WaveSculptor Software & Firmware Changes

TRI50.038 ver5
13 November 2008

The purpose of this document is to detail the differences between firmware versions TRI50v3.13 to TRI50v3.31. The differences between the WaveSculptor controls and configuration software version 2.07 to 3.05 are also described.

Illustration 1: New Configuration Dialogue Box

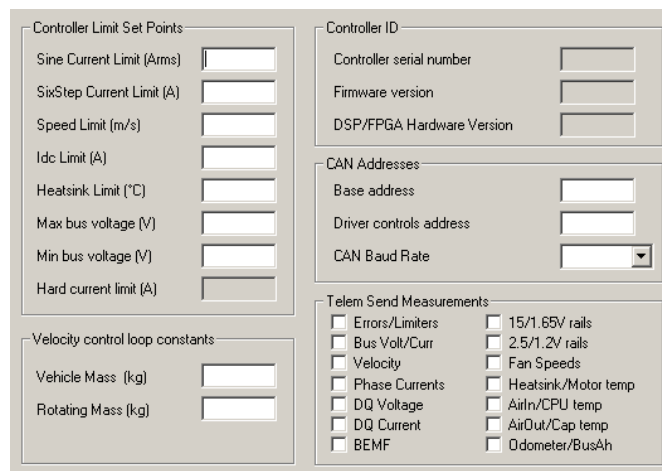
Version 2.07 of the WaveSculptor controls and configuration program has been updated to version 2.09. Version 2.09 is compatible with the new configuration version 1.01. In version 2.09, the current limit setting has been split into two, the Sine Current Limit (Arms) and the SixStep Current Limit (A), shown in the top left corner of Illustration 1. There has also been an extra setting for the software over-current set point added to the calibration screen, which should read 165A.
